**To:** Members of Dublin City Council  
**From:** Dana L. McDaniel, City Manager */mgl/dm*  
**Date:** March 16, 2017  
**Initiated By:** Vincent A. Papsidero, FAICP, Planning Director  
Jennifer M. Rauch, AICP, Planning Manager  
**Re:** Basic Plan – Parking Garage – (Case#17-003ARB-BPR)

17-003ARB/BPR  
Basic Plan Review  
Columbus Metropolitan Library - Garage  
75 N. High Street

CITY OF DUBLIN, FRANKLIN COUNTY, OHIO  
BASIC SITE PLAN  
FOR  
CITY OF DUBLIN  
PARKING GARAGE  
2017

**WEST ELEVATION**  
**Future Franklin Street**

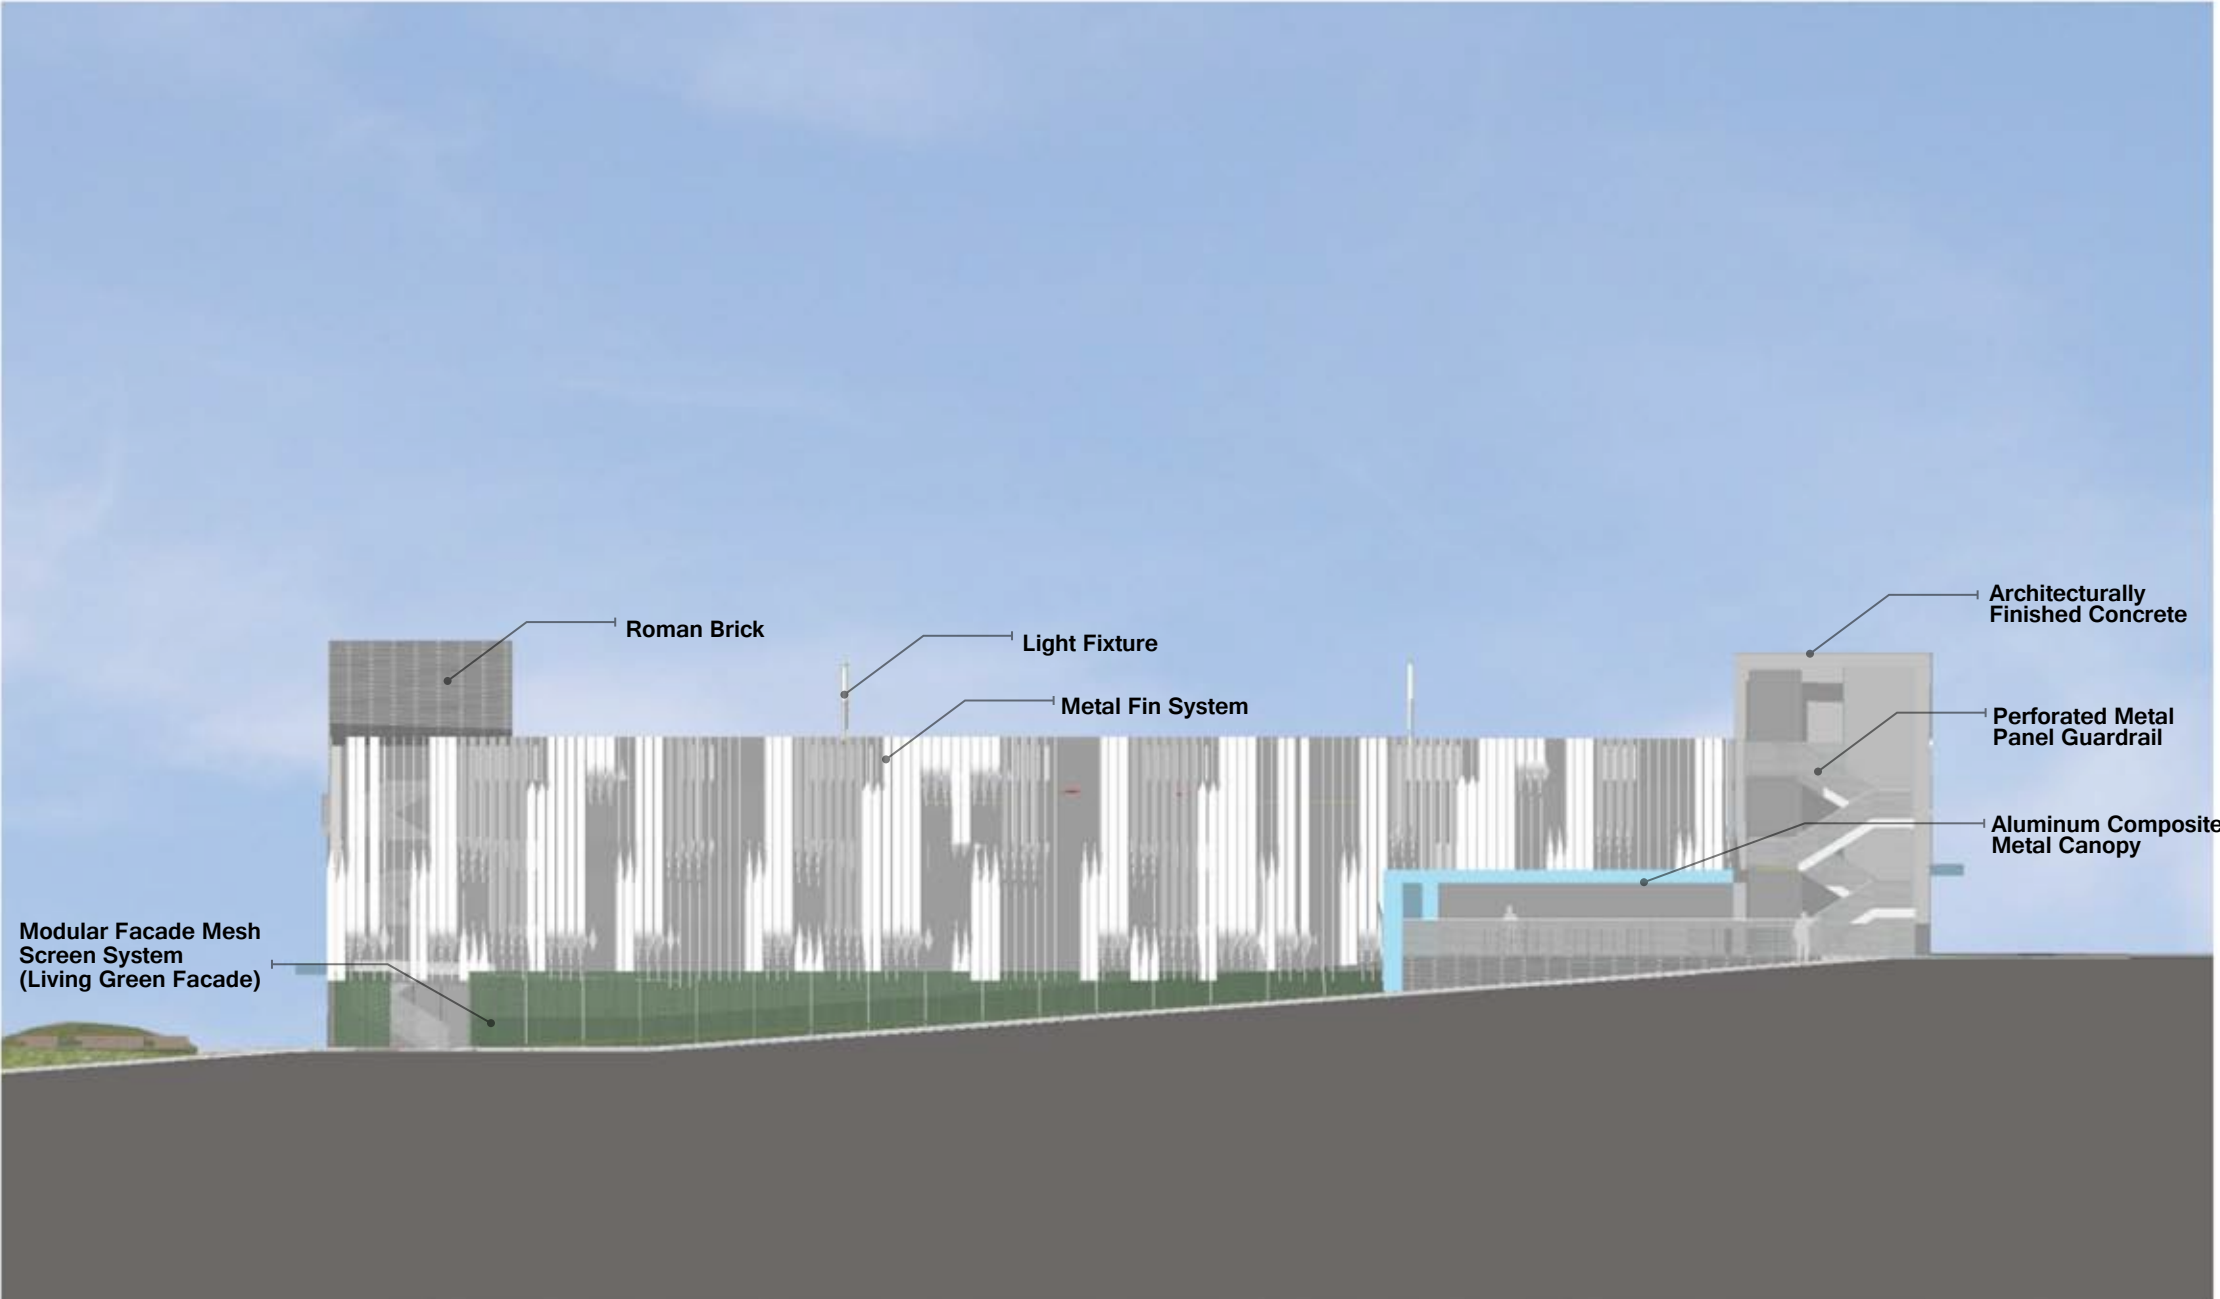
4. §153.063(D)(4)(b): Building Height – Building height limited to 2.5 stories adjacent to the Historic Core District (required); 3 stories at the north, east, and south elevations (requested).

5. §153.062(O)(12)(b): Story Height – Ground Story minimum and minimum clearance is 12 feet (required): 11 feet (requested).
6. §153.065(B)(5)(c): Story Height – Minimum clearance is 12 feet (required): 11 feet (requested).

Ms. Rauch added the proposal requires a Waiver for the ground story height at Rock Cress Parkway because the Code requires 12 feet and the proposal indicates 11 feet. The proposal meets story height requirements on the remaining elevations she said.
